JOINT REGIONAL PLANNING PANEL

JRPP No:	2014SYE101
DA No:	DA 260/14
LGA:	North Sydney
PROPOSED DEVELOPMENT:	106-108 Parraween Street, Cremorne Demolition of existing buildings and car park to accommodate a 4 storey mixed use development comprising ground level community and commercial uses, 18 apartments and basement parking including public parking
APPLICANT:	North Sydney Council
SUBMISSIONS:	Eight (8) to original Four (4) to amended plans
Regional Development Criteria (Schedule 4A of the Act)	Council owned property; Capital Investment Value > \$5M
List of All Relevant s79C(1)(a) Matters	North Sydney LEP 2013 - Zoning – B4 Mixed Use North Sydney DCP 2013 S94 Contribution SEPP 55 - Contaminated Lands SREP (2005) SEPP 65 Design Quality of Residential Flat Development
List all documents submitted with this report for the panel's consideration	Conditions Amended Plans Design Excellence Panel comments Community Services Department comments Traffic Management Plan – January 2015

Assessment Report and Recommendation

Figure 1 – area outside BHP on Langley Avenue

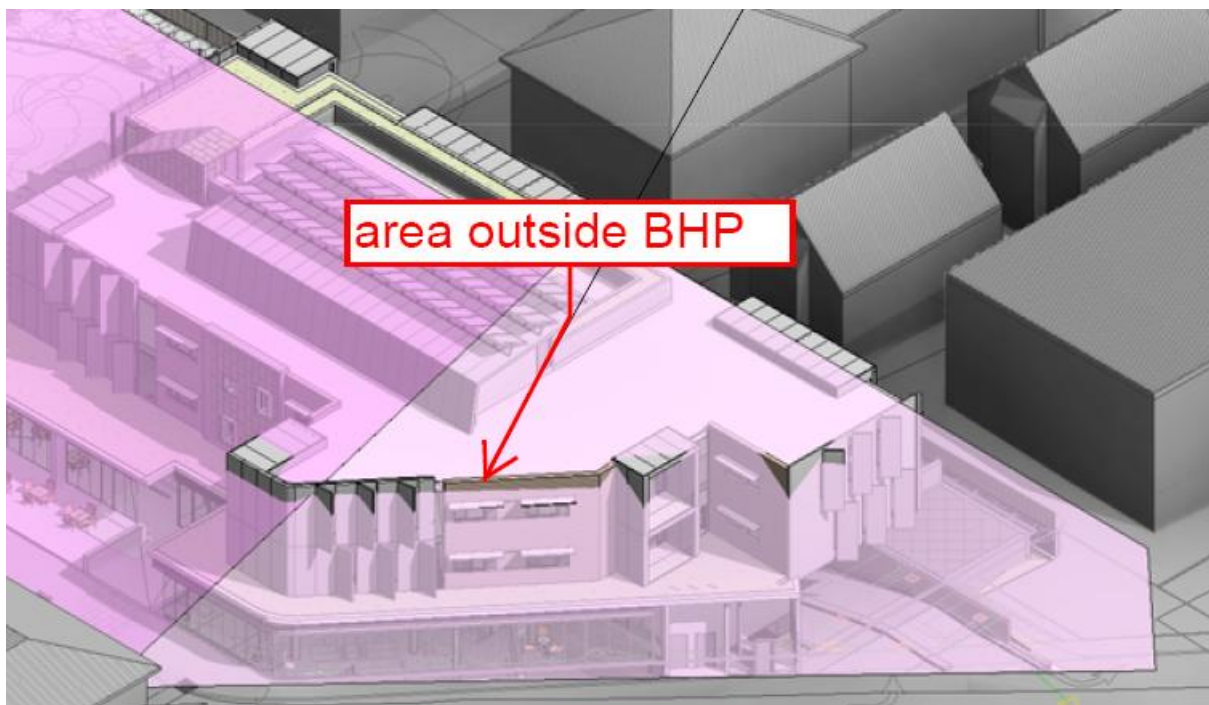
The extent to which the proposal breaches the BHP is indicated in **Figures 1 and 2**.

As can be seen in the above, the extent of the breach is very minor. Further it does not result in any unreasonable visual or overshadowing impacts. Given this and the

overall quality of the design, the variation is supported in this circumstance.
